Executive Order G-70-14-E

Relating to the Modification of the Certification of the
Red Jacket Aspirator Assist Service Station
Phase II Vapor Recovery System

IT IS ORDERED AND RESOLVED: That the certification issued on May 16, 1979, for the Red Jacket aspirator assist, Phase II vapor collection and disposal system licensed to and marketed by Wylain, Incorporated, Red Jacket Pumps Division, is hereby modified to allow use of the Dresser Wayne Decade Marketer overhead hose configuration without anti-recirculation valve, as an alternate hose configuration. The system hereby modified is certified to be at least 95 percent effective with manifolded vents for attendant/self serve use and at least 90 percent effective with nonmanifolded vents for attendant/self serve use at gasoline service stations in conjunction with Phase I vapor recovery systems which have been certified by the Air Resources Board. The system is described in Exhibits 1, 2, 3, 4, and 5 attached hereto.

Exhibit 5 (Corrected 4-1-80)
Executive Order G-70-14-E

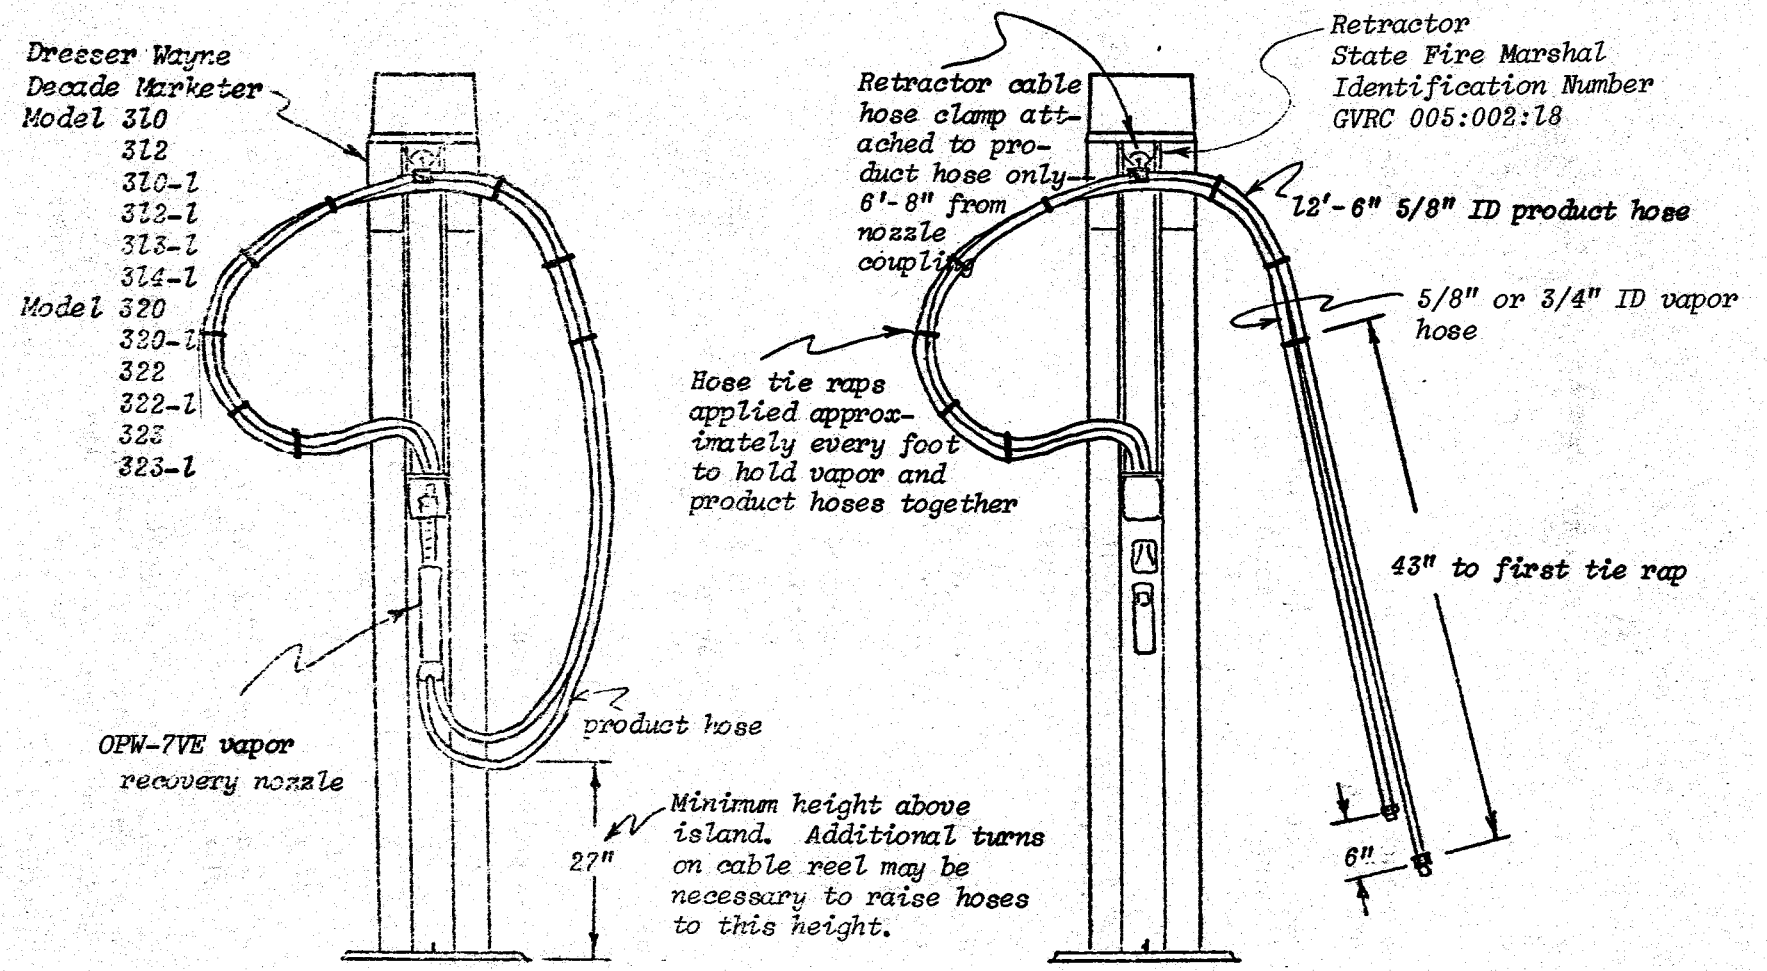
Notes: 1. Recirculation trap not required.
2. Hose swivels not required at dispenser end of hoses.
